Richard C. Slade & Associates, LLC
Hydrology Response

DRAFT MEMORANDUM

Re: Response to Public Comments
Proposed Mountain Peak Winery (Application #P13-00320)
3265 Soda Canyon Road, Napa County, California

October 11, 2016 Letter from Kamman Hydrology & Engineering, Inc. (Kamman 2016)

FIGURE A
IDEALIZED CONE OF DEPRESSION DIAGRAM

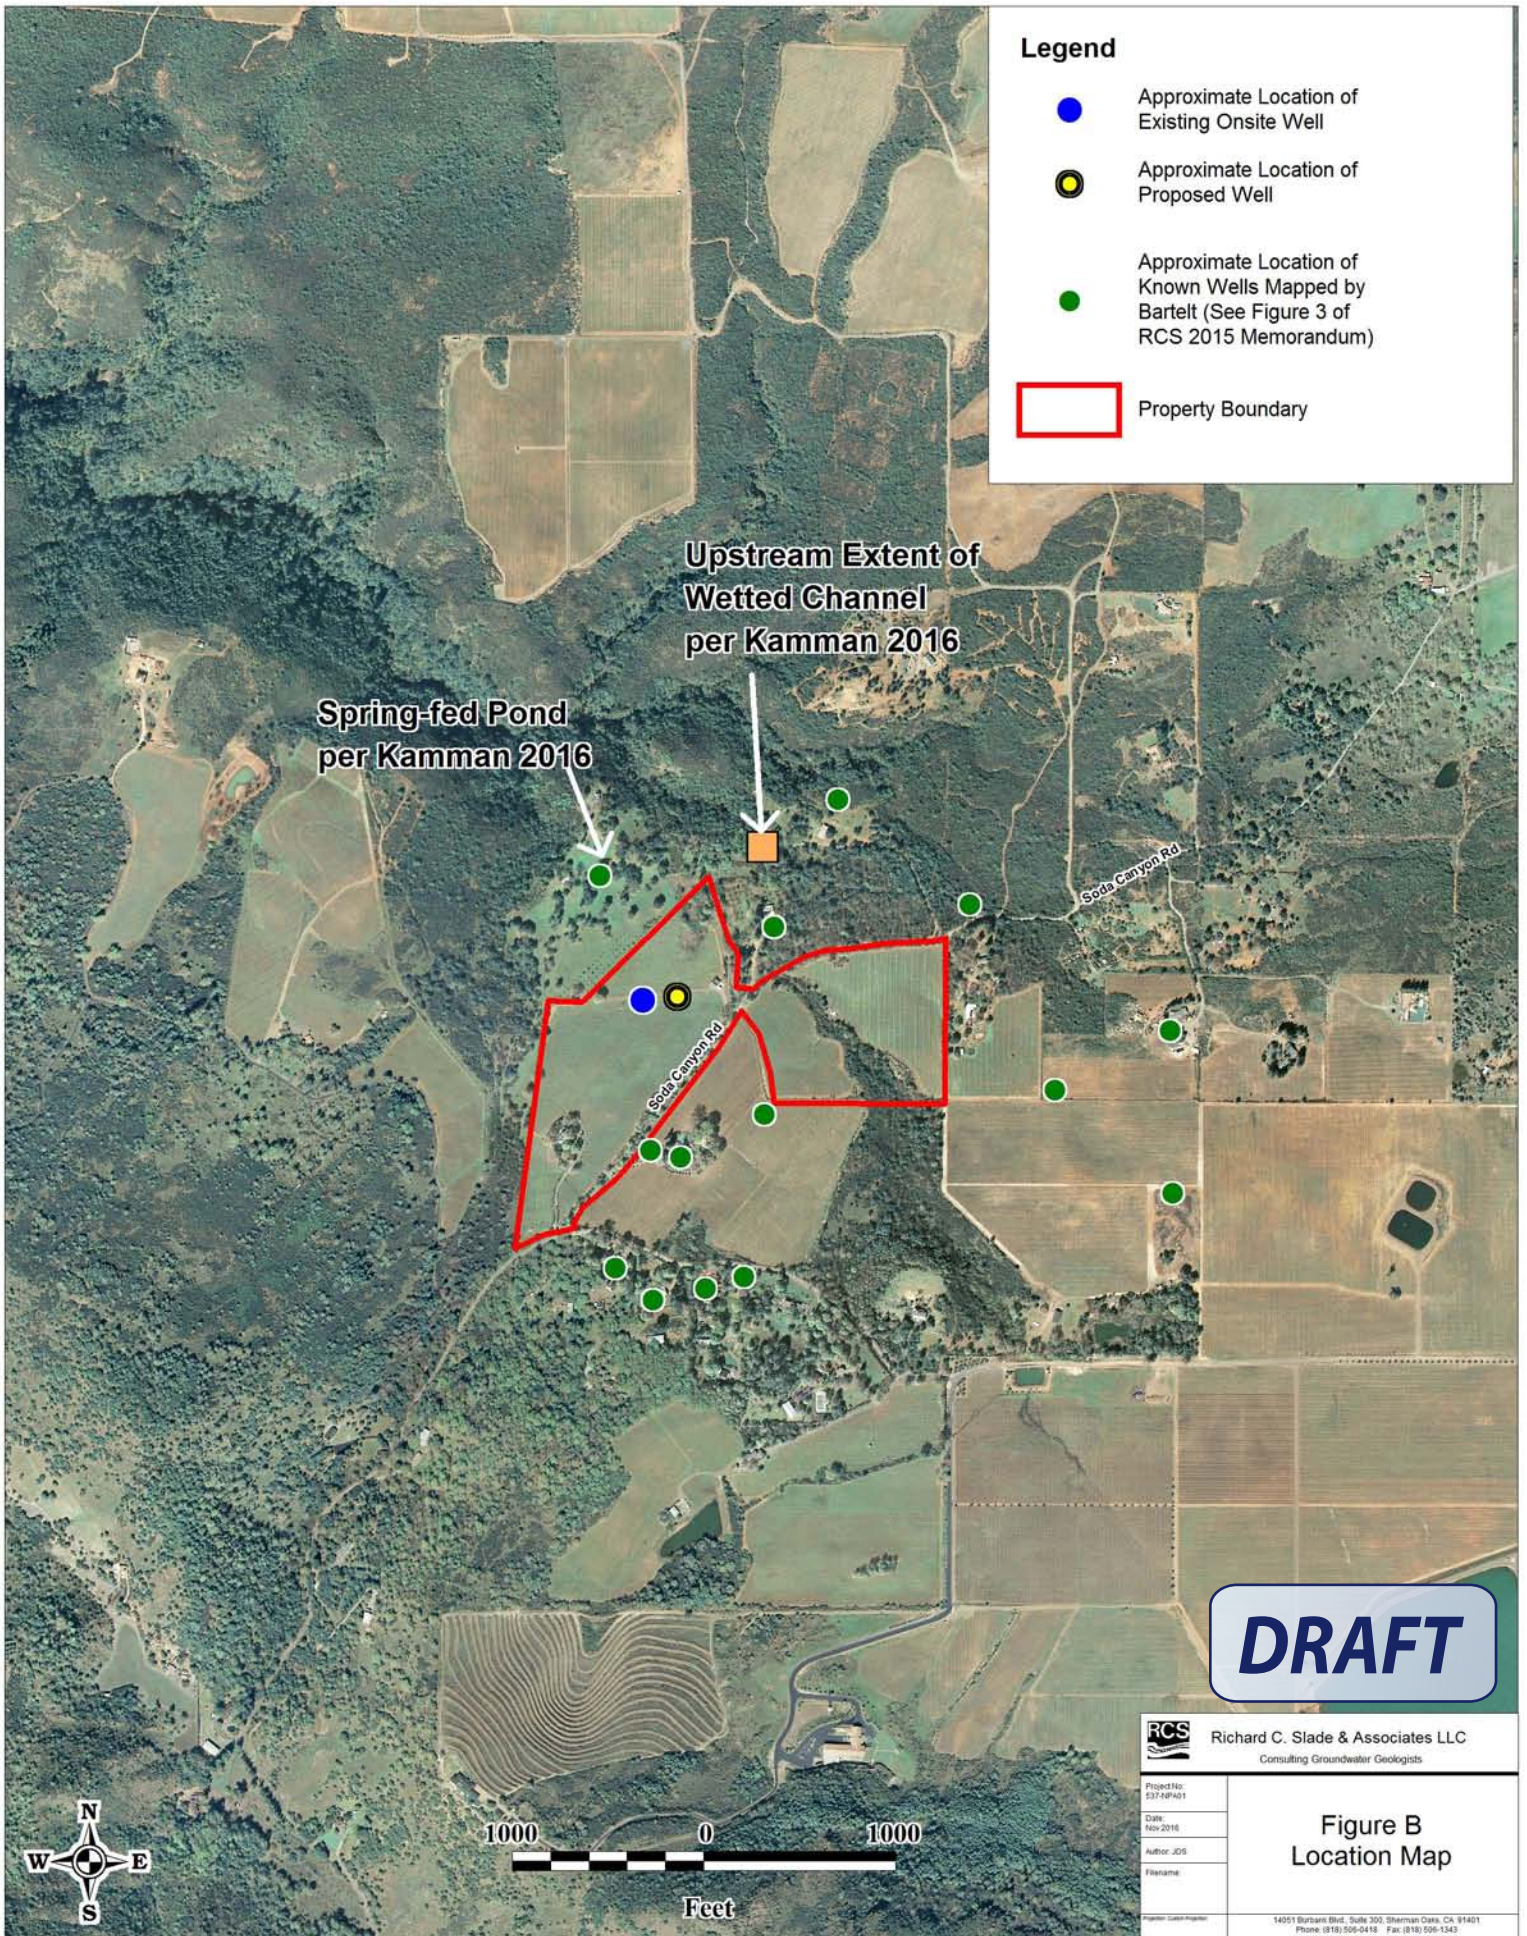
Nor are there any offsite well impacts under the 2015 WAA Guidelines “Default Well Interference Criteria” (Page 9, Table 2B therein). Table 2B includes the “the minimum significant drawdown values... intended for use in cases where information about existing non-Project wells is limited or non-existent.” (WAA 2015). For the existing onsite well, the 3.3 ft of water level drawdown and the 7 ft of water level drawdown are both less than the default well interference significance criteria presented in the Napa County Water Availability Analysis Guidelines (See WAA Page 9, Table 2B). This is consistent with the basic hydrogeology principle that self-induced water level drawdown in a pumping well is always greater than the water level drawdown interference that would be induced in any other onsite or offsite well. This water level drawdown phenomenon is described in hydrogeology textbooks as a “cone of depression,” wherein the greatest water level drawdown is created in the well casing of the pumping well, with a decreasing amount of water level drawdown being induced as distance from the pumping well increases. **Figure A**, “Idealized Cone of Depression Diagram,” has been adapted from Freeze & Cherry (1979), to illustrate water level drawdown effects in an idealized aquifer. For the subject property, this clearly means that potential water level drawdown impacts from onsite pumping on other “sensitive receptors” would be only a fraction of either 3.3 ft when the onsite well is pumping at 50 gpm, or 7 ft when this well is pumping at 100 gpm (the two drawdown values observed in the onsite well while pumping).

FIGURE C
RESULTS OF CURVE-FITTING ANALYSIS

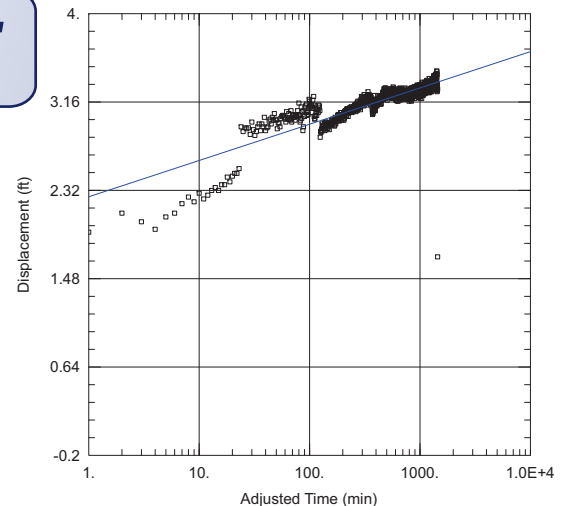
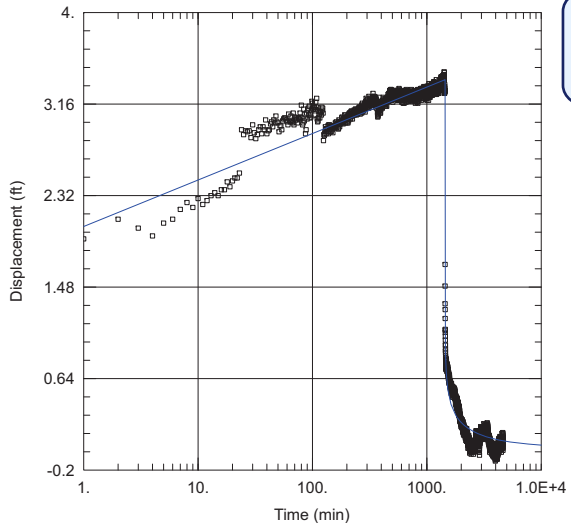
Water level drawdown data and recovery data collected during the Project pumping test were input into the software program AQTESOLV Professional (version 4.5). Numerous analytical solutions were utilized to determine transmissivity values using an automatic curve fitting procedure. **Figure C** – “Results of Curve-Fitting Analysis” shows two of the

numerous solutions analyzed. Based on those data, a transmissivity of 4,100 ft²/day (30,668 gpd/ft) is considered to be representative for the fractured rock aquifers in the vicinity of the Project property.

FIGURE D THEORETICAL WATER LEVEL DRAWDOWN CALCULATIONS

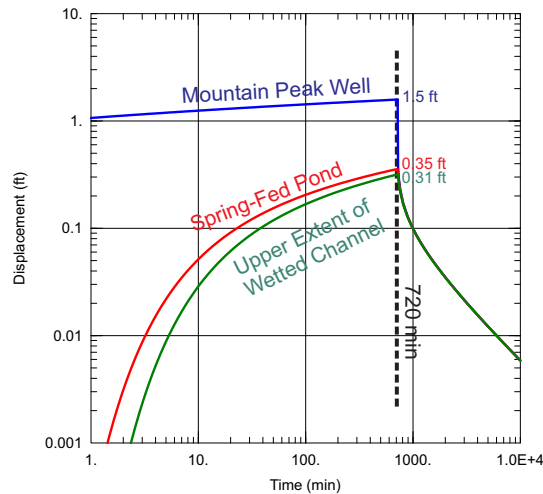
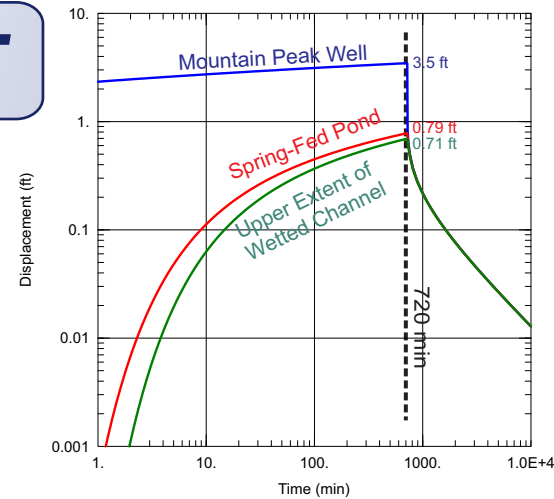
Using the assumptions described above, Figure D “Theoretical Water Level Drawdown Calculations,” has been prepared to show the calculated water level drawdown values at the “spring-fed pond” and the “upper extent of wetted channel” following 720 minutes of continuous pumping at the for two different pumping rates: at a constant rate of 21 gpm and at a constant rate of 46 gpm. A summary of the results of the AQTESOLV software calculations are as presented in the following Table:

Mountain Peak (Mtn Pk) Well Pumping Rate	WL Drawdown inside Mtn Pk Well Casing	WL Drawdown @ “Spring-Fed Pond” (700 ft from Mtn Pk Well)	WL Drawdown @ “upper extent of wetted channel” (900 ft from Mtn Pk Well)
21 gpm for 720 minutes	1.5 ft	0.35 ft	0.31 ft
46 gpm for 720 minutes	3.5 ft	0.79 ft	0.71 ft

These theoretical drawdown values (i.e., theoretical water level interference values) at both the “spring-fed pond” location and the “upper extent of wetted creek” location, respectively, are less than 0.5 ft; such small water level changes while pumping the Project well are very likely immeasurable, due to natural fluctuations in the flow of springs/seeps. These values are also far less than the “Default Well Interference Criteria” shown on Table F-1 of the May 12, 2015 Napa County WAA Guidelines. In addition, in our long-term experience in the field monitoring of water levels in wells during actual pumping tests, RCS has typically found that theoretically-calculated values are virtually always greater than the actual field-monitored values.

RICHARD C. SLADE & ASSOCIATES LLC Consulting Groundwater Geologists	Project No: 837-MP-01
	Date: November 2015 Author: ASH
Figure E Watershed Boundaries	
14051 Burbank Blvd., Ste. 300, Sherman Oaks, CA 91401 Phone: (818) 506-0416 Fax: (818) 506-1343

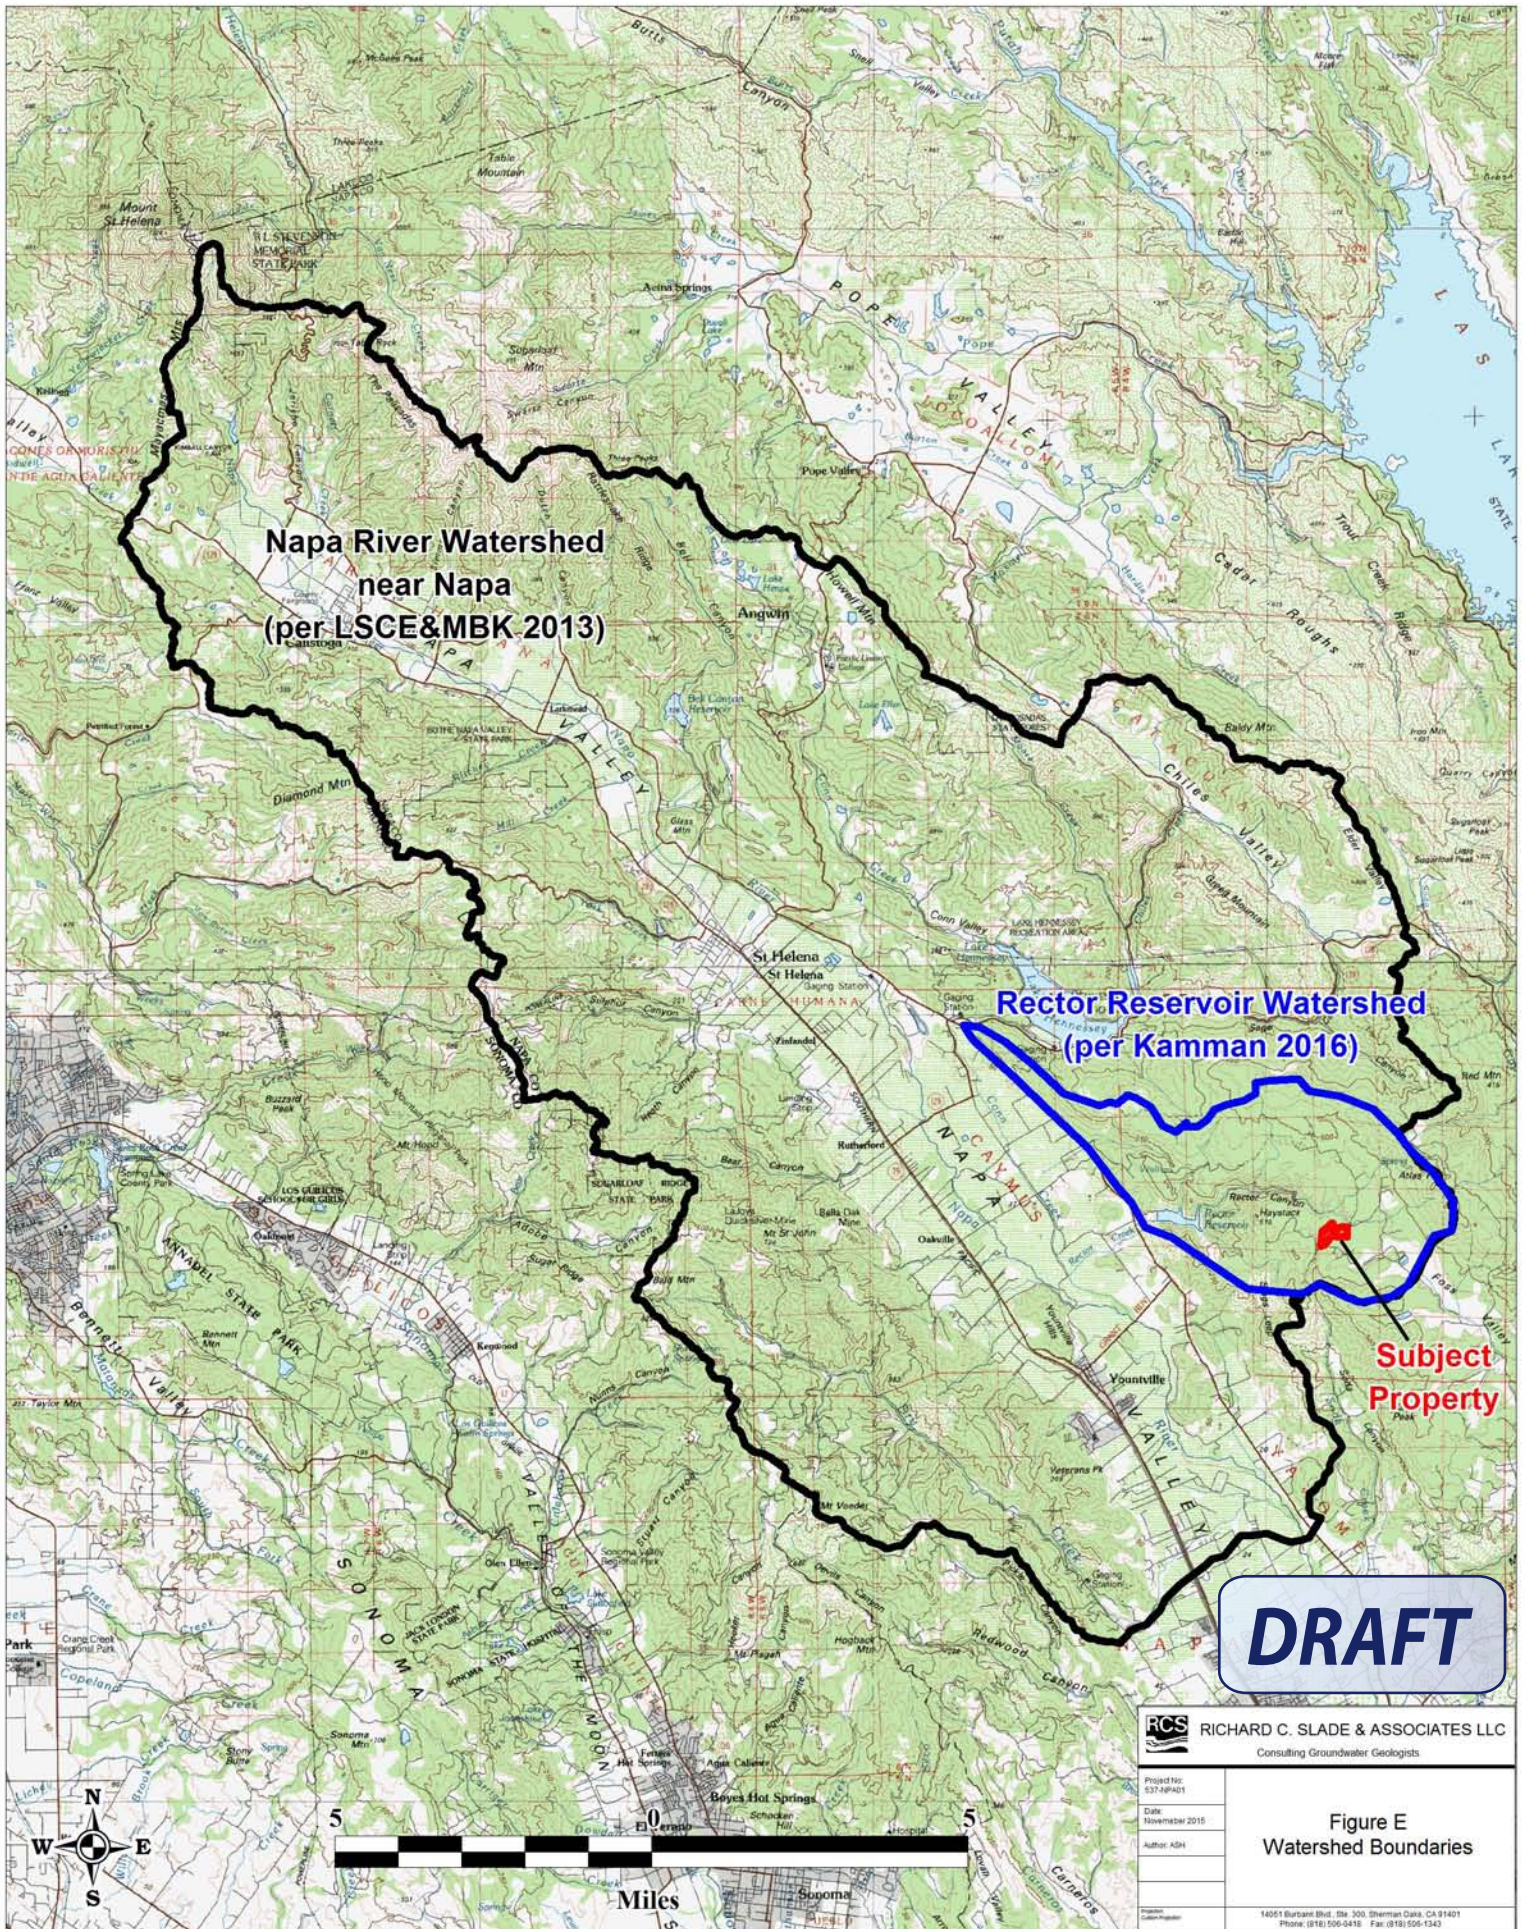
A watershed-wide assessment can also be made using the BCM data. Such use is consistent with the recommended "watershed-scale evaluations" described in the "limitations of use" section of the document that is distributed with the BCM dataset. Figure E, "Watershed Boundaries" illustrates two watershed boundaries: the "Napa Watershed near Napa" boundary adapted from LSCE&MBK 2013; and the approximate "Rector Reservoir Watershed" from Figure 2 of Kamman 2016. The Project property lies within the latter watershed. Using the same zonal statics calculations on those watershed polygons with GIS software in conjunction with the BCM gridded data sets, the same calculation was performed as was described above, and the results of those calculations are presented in Table C "Watershed-scale Calculated Rainfall Recharge Percentage Using BCM Dataset".

As shown in Table C, the watershed-scale calculations using the BCM data suggest that the calculated rainfall recharge percentage for the “Rector Reservoir Watershed” (proposed by Kamman 2016) is roughly 93% of the calculated rainfall recharge percentage for the “Napa River Watershed Near Napa” (this is calculated as $28\% \div 30\% = 93\%$). This same ratio between the larger “Napa River Watershed Near Napa” watershed and the smaller “Rector Reservoir Watershed” can be applied to the actual calculated data presented in the LSCE&MBK 2013 report. In Table 8-9 of that LSCE&MBK 2013 report, the rainfall deep percolation percentage for the “Napa River Watershed Near Napa” was estimated to be 17%. Taking 93% of the LSCE&MBK-reported percentage (17%) yields a deep percolation percentage of 15.8% for the “Rector Reservoir Watershed” in which the Project property is located. This value is also higher than the 14% deep percolation presented in the RCS 2015 Memorandum.
